APPENDIX B
COMMENTS RECIEVED

ADDITIONAL COMMENT ON FINAL EIA REPORT

FOR CALEDON WIND FARM

**DEA 12/12/20/1701
DEA&DP E12/2/4/7-E4/5-CJ2247/11**

Figure 1: Part of Overberg showing 4 potential Wind Farms

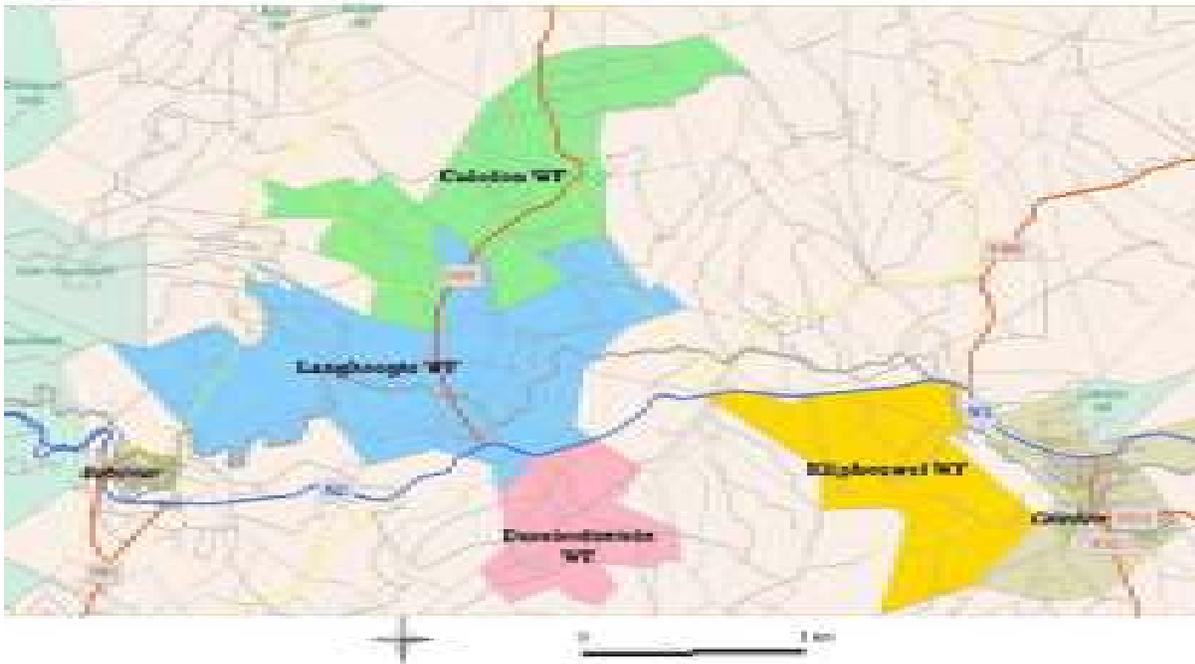
These impacts would be compounded by the development of more than one Wind Farm in the area. Of specific concern is the cumulative impact on the landscape around the N2 corridor and R43. Based on the findings of the VIA and SIA the establishment of more than one, large Wind Farm in the area was *therefore not supported* and the recent reduction to 31 turbines has produced no significant improvements.

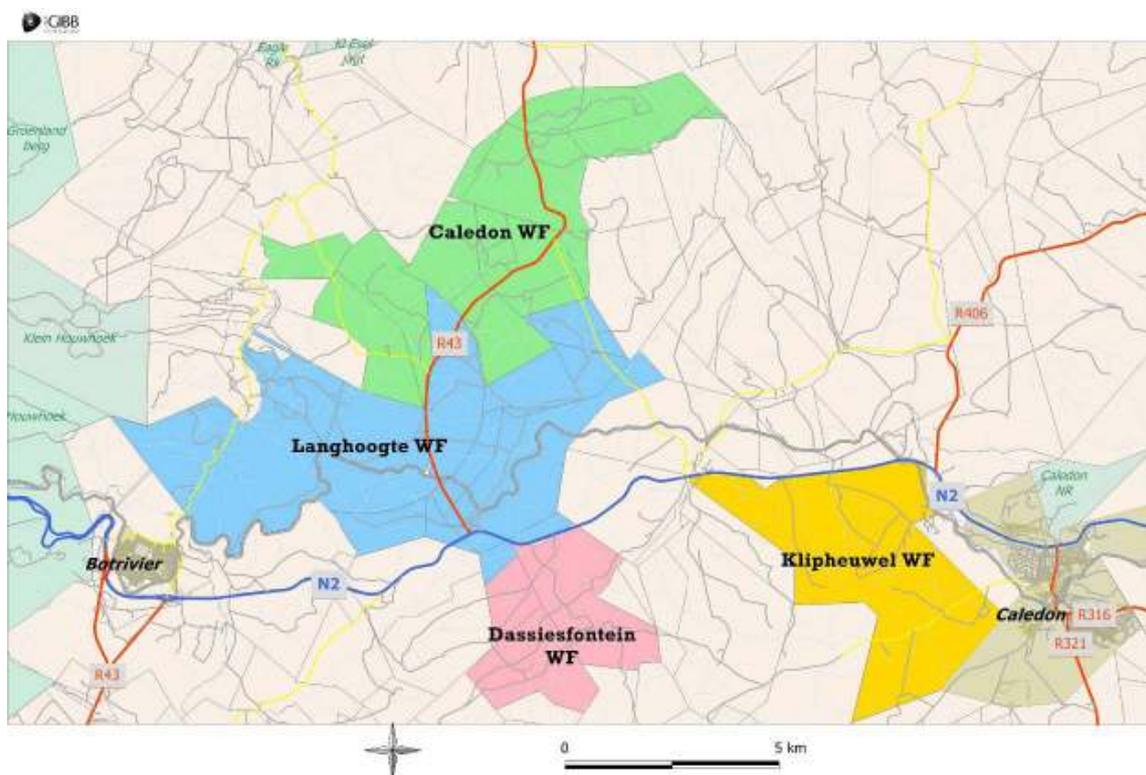
We reiterate our concerns regarding the cumulative impacts of several wind farm projects in the same area as shown in the map below.
